**Hurricane Sandy Repairs to the Newport Cliff Walk**

Bailey's Beach to Ruggles Avenue

ADDENDUM NO. 3 Prospective bidders and all concerned are hereby notified of the following changes in the Plans, Specifications, Proposal and Distribution of Quantities for this contract. These changes shall be incorporated in the Plans, Specifications, Proposal and Distribution of Quantities, and shall become an integral part of the Contract Documents.

FED. ROAD DIV. NO.	STATE	FEDERAL AID PROJECT NO.	FISCAL YEAR	SHEET NO.	TOTAL SHEETS
	RI		2013	21	38

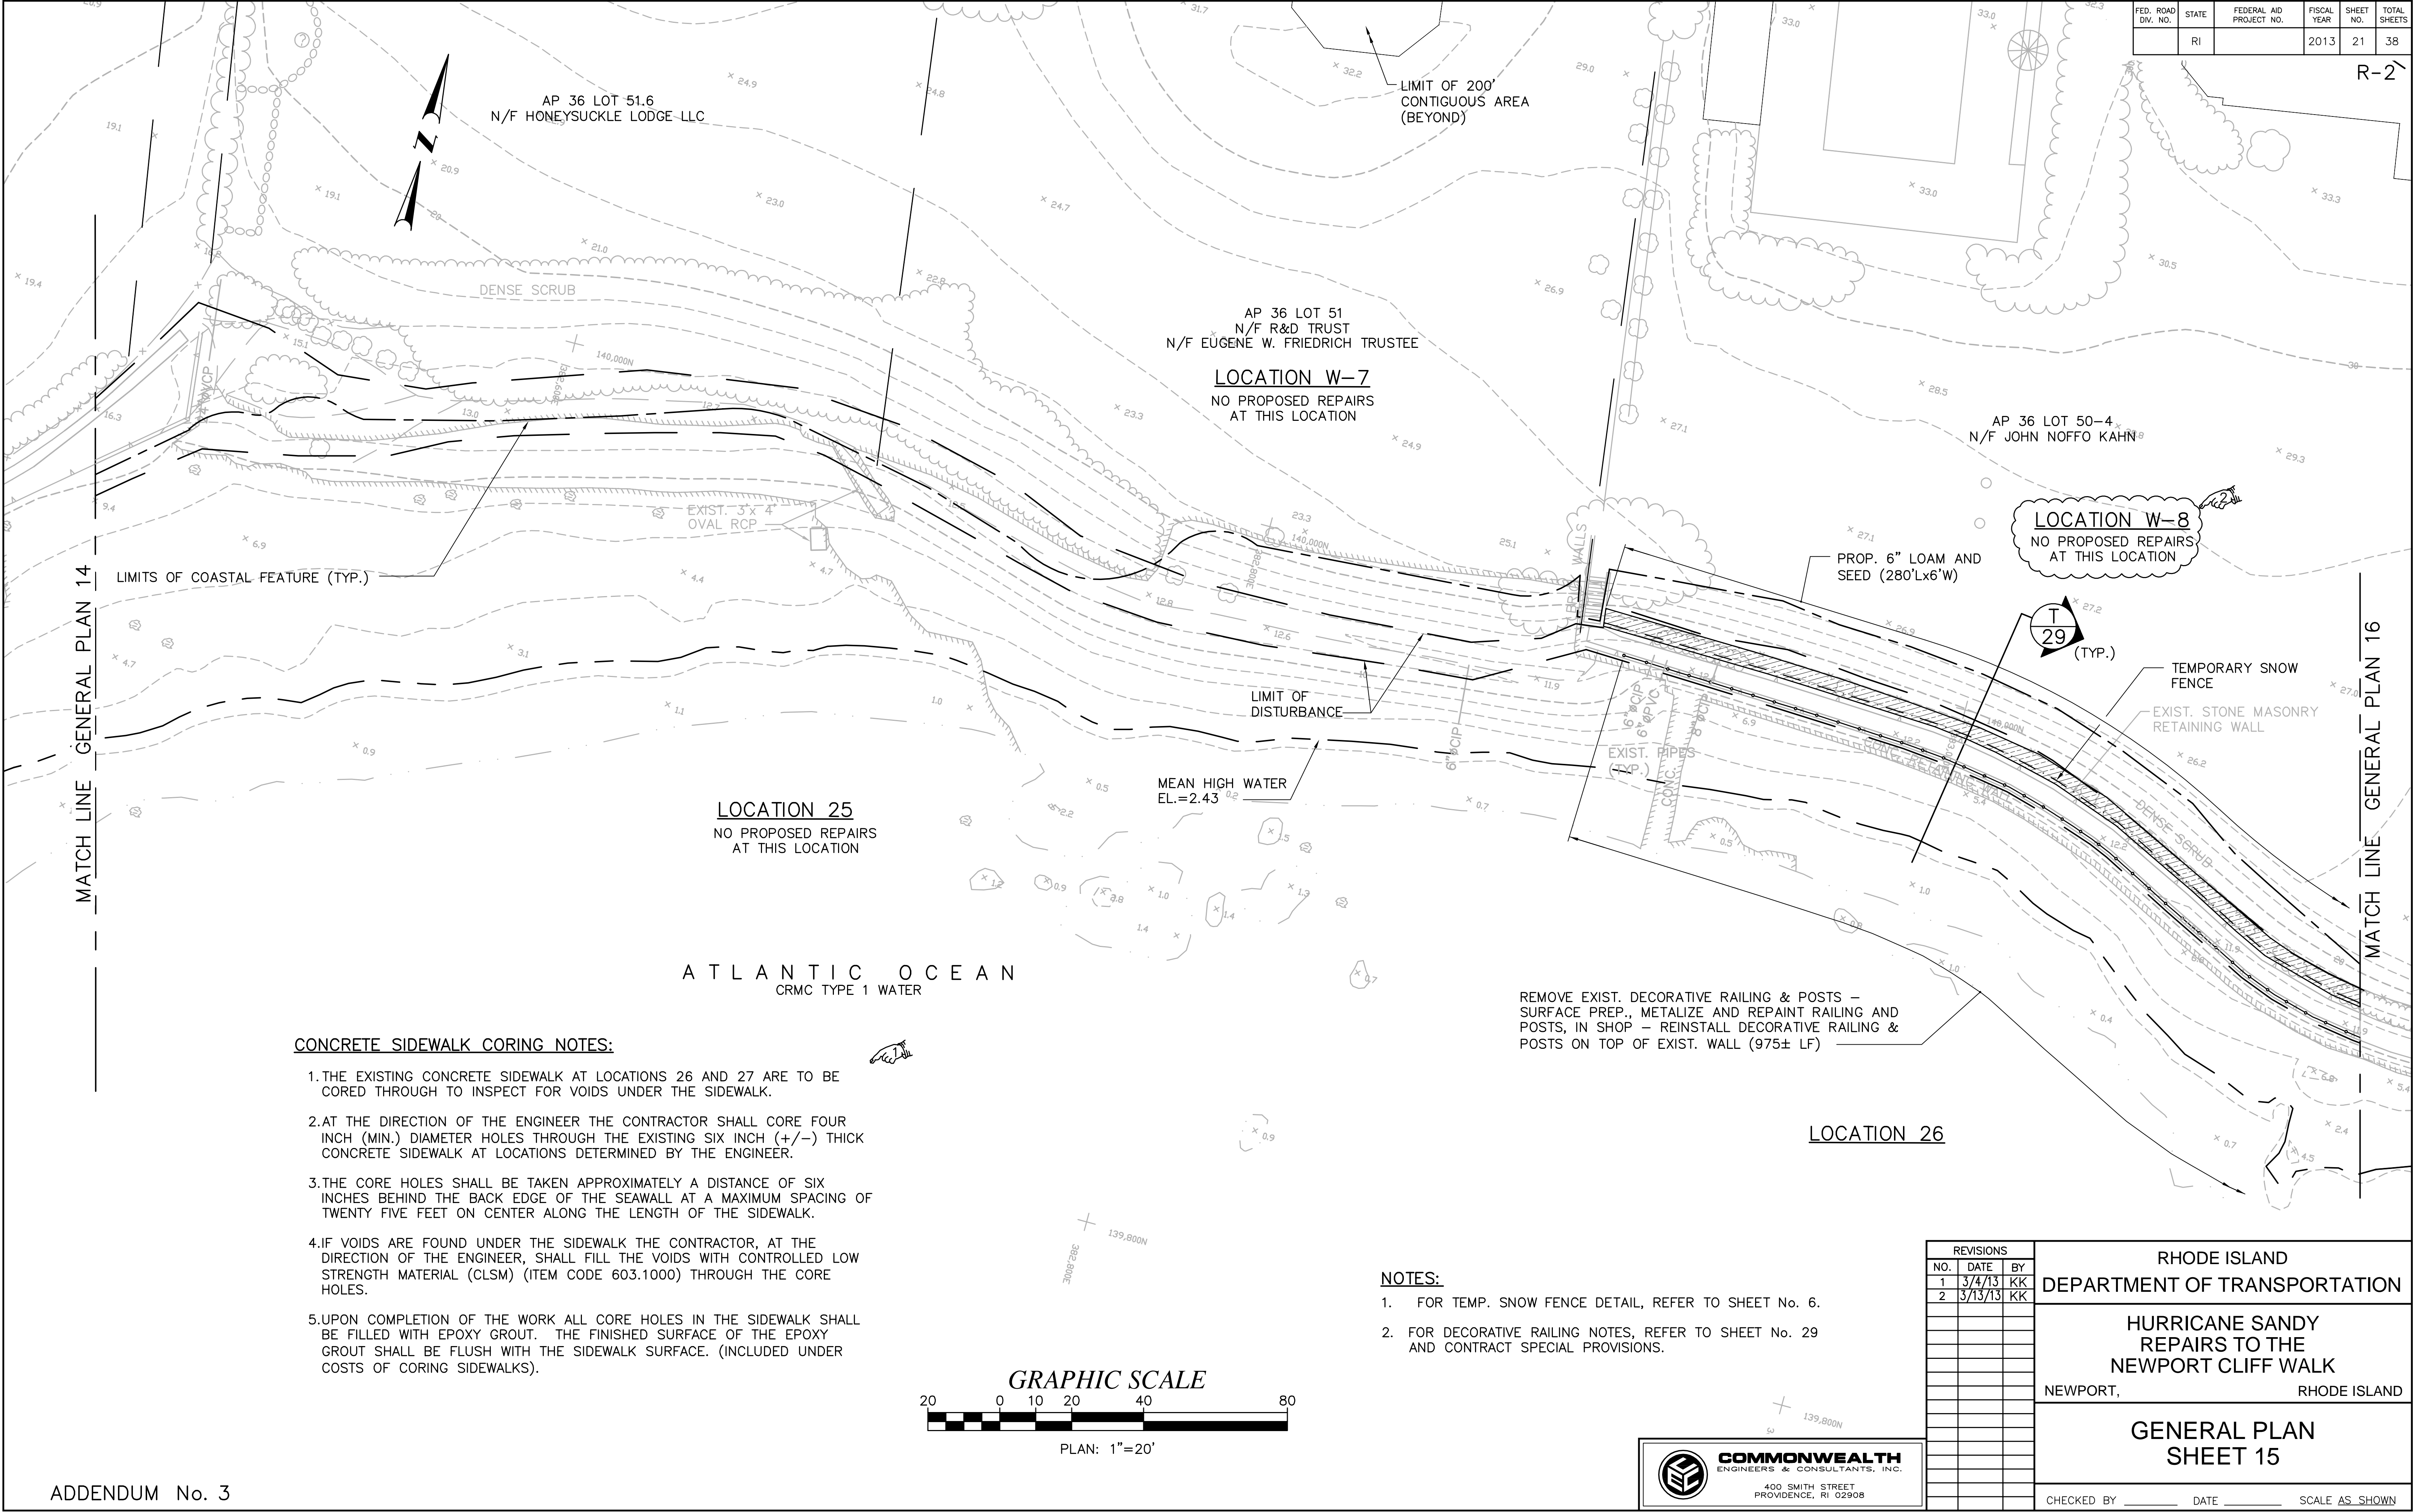
- 4. Sheet No. 21 (R-1) - General Plan Sheet 15  
Remove Sheet No. 21 (R-1) in its entirety and replace it with revised Sheet No. 21 (R-2) attached to this Addendum No. 3. A Note has been added in regards to Location W8.

EXISTING DECORATIVE RAILING NOTES:

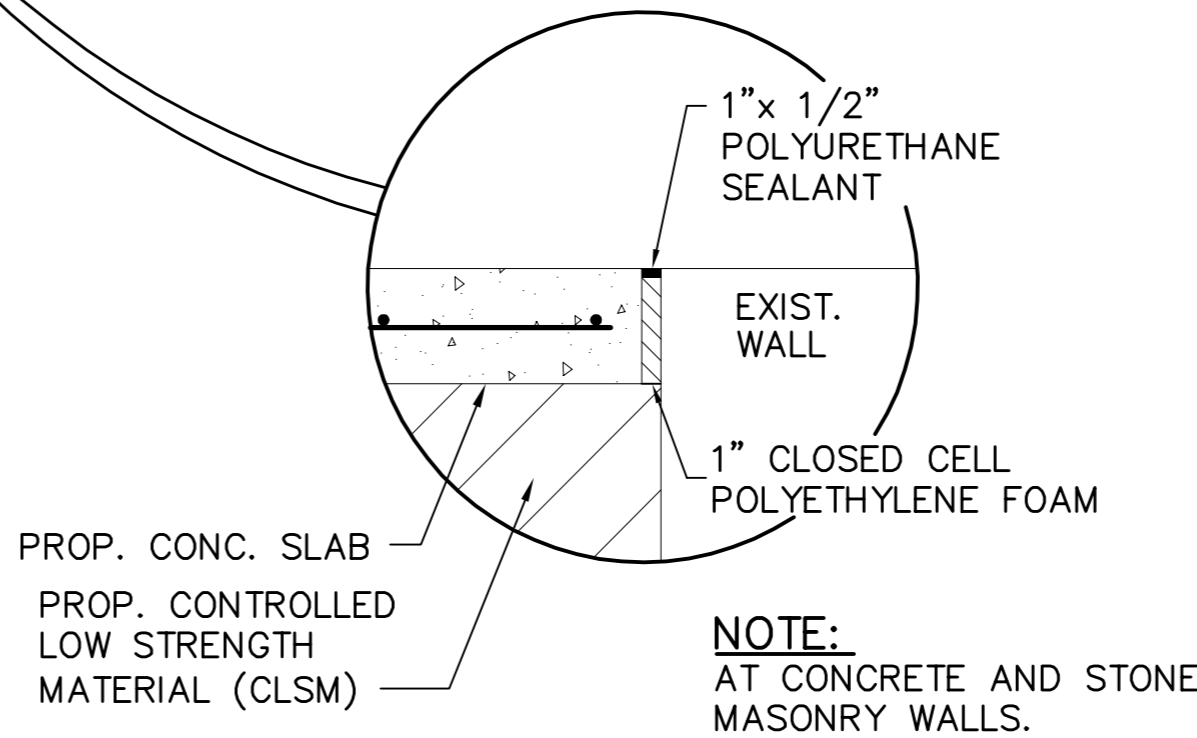
Remove Sheet No. 29 in its entirety and replace it with revised Sheet No.29 (R-1) attached to this Addendum No. 3. The "Existing Decorative Railing Notes" have been revised.

1. THE EXISTING DECORATIVE RAILING AT LOCATIONS 22, 26 AND 27 ARE TO BE REFURBISHED AS DESCRIBED BELOW AND IN THE SPECIAL PROVISIONS OF THE CONTRACT DOCUMENTS. DETAILS OF THE EXISTING DECORATIVE RAILING ARE SIMILAR TO THE NEW DECORATIVE RAILING DETAILS SHOWN OF SHEET 31.

2. THE EXISTING RAILINGS AND POSTS ARE TO BE CAREFULLY REMOVED FROM THE TOP OF THE EXISTING SEA WALLS WITHOUT DAMAGING THE TOP OF THE WALLS OR THE STEEL RAILING COMPONENTS. THE CONTRACTOR SHALL DOCUMENT THE PRESENT LOCATION OF THE EXISTING POST AND RAIL ELEMENTS SO THAT THEY CAN BE REINSTALLED IN THE SAME LOCATION. LOW STRESS STEEL DIE STAMPS (AT LOCATIONS WHICH WILL NOT BE OBSCURED BY THE METALIZING/PAINT) CAN BE USED TO IDENTIFY PIECES. THE EXISTING CORE HOLES IN THE TOP OF THE WALL SHALL BE CLEANED OUT OF ANY GROUT OR DEBRIS TO CLEAR THE HOLES FOR REUSE. ANY DAMAGE TO THE EXISTING WALLS OR STEEL RAILING AND POSTS WILL BE REPAIRED OR REPLACED AT THE DIRECTION OF THE ENGINEER AND AT NO ADDITIONAL COST TO THE STATE.

- a.REMOVE REMNANTS OF GROUT FROM POSTS
  - b.CLEAN ALL STRUCTURAL STEEL
  - c.REPAIR EXISTING WELDS AS NECESSARY
  - d.SURFACE PREPARATION OF THE STEEL RAILINGS AND POSTS SHALL BE TO MEET SSPC-SP10 STANDARDS "NEAR-WHITE BLAST CLEANING".

6. THE CONTRACTOR SHALL PROVIDE NEW BOLTS, NUTS AND OVERSIZED WASHERS. THE BOLTS AND NUTS SHALL CONFORM TO ASTM A307 AND ASTM 563 GRADE A RESPECTIVELY. THE WASHERS SHALL BE HARDENED STEEL COMMERCIAL TYPE 'A' PLAIN WIDE WASHERS AND SHALL MEET THE DIMENSIONAL REQUIREMENTS OF ANSI B.18.22.

11. THE POSTS SHALL BE RESET IN THE EXISTING HOLES IN THE TOP OF THE WALL WITH AN EPOXY GROUT.
